**SSD 76397489 – CANVAS ESTATE – ENVIRONMENTAL IMPACT STATEMENT –
PUBLIC EXHIBITION - FAIRFIELD COUNCIL SUBMISSION**

ATTACHMENT - A – Detailed technical advice and requirements

Figure 1 – Example of Subsoil Drainage System

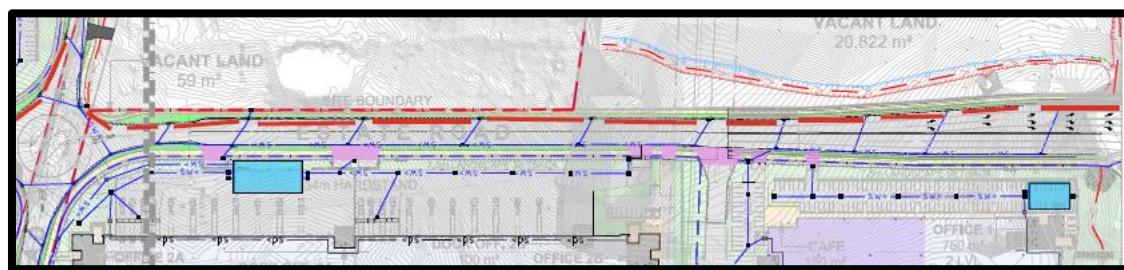
- V. **Subsoil Drainage System**
 - Provision of a subsoil drainage system shall be considered along the kerb and gutter in locations where there is no proposed stormwater drainage pipeline. The intent is to prevent pavement moisture ingress and improve subgrade performance. An example of the required subsoil drainage locations is indicated on the figure below with a red dashed line.

Figure 3 – Discharge Point

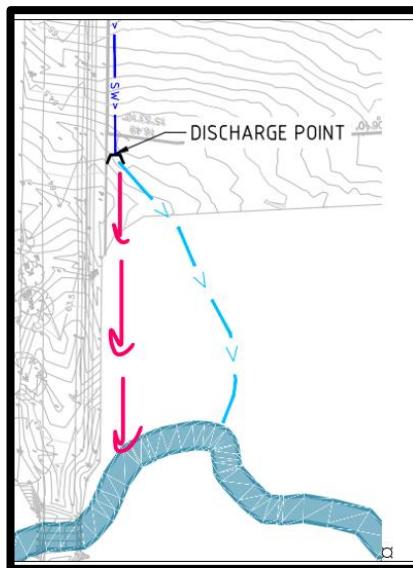
- The stormwater pipe system with the culvert outlet to avoid entering private property and connect directly to the creek as Stopping short of the creek would lead to excess overflow towards the private property and not acceptable by the respective owner of the land See figure 3 below.

Figure 4 – Noise Monitoring Locations and Noise Sensitive 1662 the Horsley drive and 1642-1648 the Horsley drove, Horsley park.

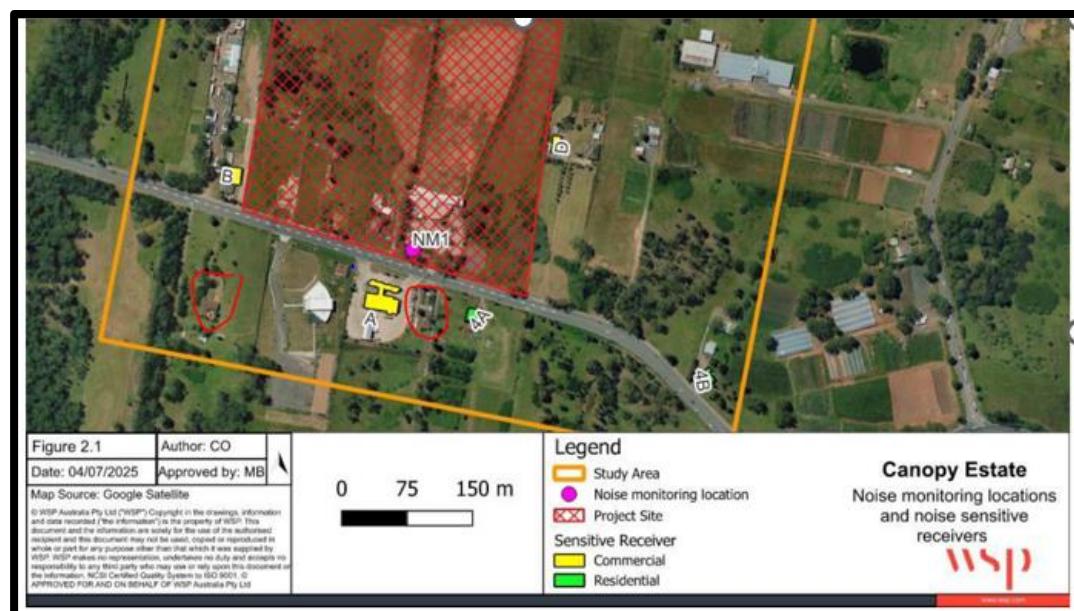
- The acoustic consultant has not identified all the nearest residential receivers to the proposed development. The acoustic consultant shall identify all the nearest residential receiver and assess the noise impact of the proposal. See in Figure 4 below, in particular to the south of the site circled in red show residential receivers have not been identified.

The consultant shall demonstrate that all residential receivers have been identified in the assessment. The consultant will need to demonstrate that the noise assessment has considered the impulsiveness or intermittent factors associated with air brake release on trucks and heavy vehicles as part of the modifying factors in Section 4.1.1.3 of the report.
